**VILLAGE OF DOWNERS GROVE  
REPORT FOR THE VILLAGE COUNCIL MEETING  
JUNE 5, 2012 AGENDA**

<b>SUBJECT:</b>	<b>TYPE:</b>	<b>SUBMITTED BY:</b>
Annexation with Rezoning to B-2, Lot Consolidation and Special Use for a drive-through use	<ul style="list-style-type: none"> <li>✓ Resolution</li> <li>✓ Ordinance</li> <li>Motion</li> <li>Discussion Only</li> </ul>	Tom Dabareiner, AICP Community Development Director

A resolution and ordinances have been prepared for annexation, rezoning, lot consolidation and special use for a Walgreens store at the northwest corner of 63<sup>rd</sup> Street and Woodward Avenue.

**To:** Plan Commission  
**From:** Jeff O'Brien, AICP, Planning Manager  
**Subject:** PC-39-11, Annexation with Rezoning to B-2, General Retail Business, Final Plat of Subdivision for Lot Consolidation and Special Use for a drive-through use – Northwest corner of 63<sup>rd</sup> Street and Woodward Avenue  
**Date:** January 9, 2012

Email and Traffic Consultant Memo regarding Turn Restrictions

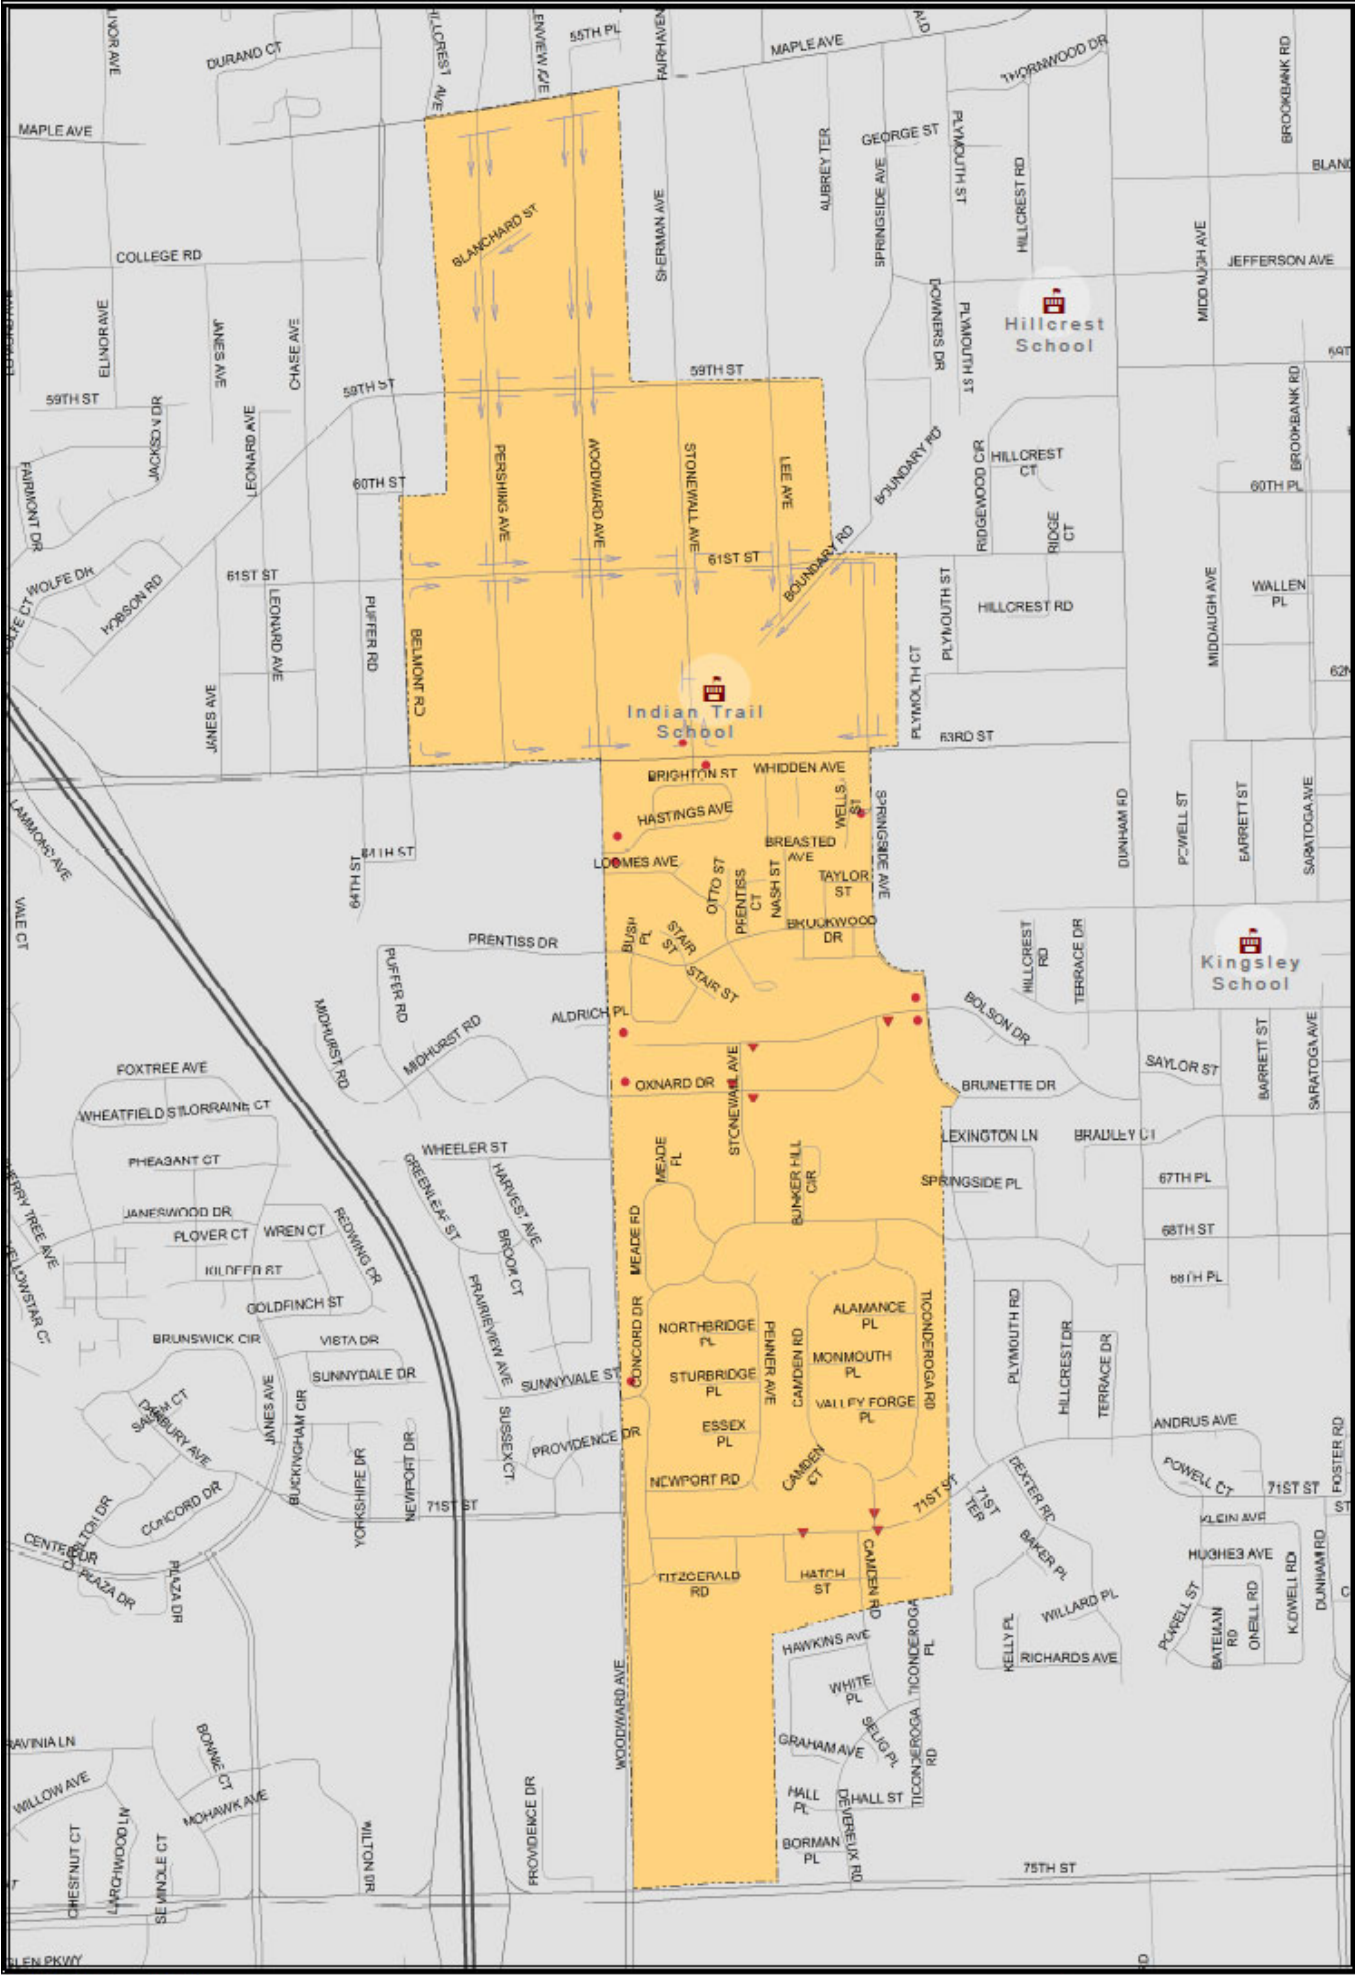
- Vehicles leaving Walgreens and destined to the south or east can readily exit Woodward Avenue via a right turn. Thus it may make sense to also prohibit left turns out via signage at the access on 63<sup>rd</sup> Street.
- However, we believe it is very important to still allow eastbound left turns into the site from 63<sup>rd</sup> Street. Our Traffic Impact Study (TIS) indicates that about 25% of Walgreens traffic would approach from the west on 63<sup>rd</sup> Street. Without left turns in, all of these vehicles would be forced to make a left turn at Woodward, and then make another left turn into the site. The inconvenience of the additional left turn maneuver could hinder business. And the additional traffic load through the 63<sup>rd</sup> Street / Woodward Avenue and on Woodward Avenue along the site would be unnecessary and unwanted.
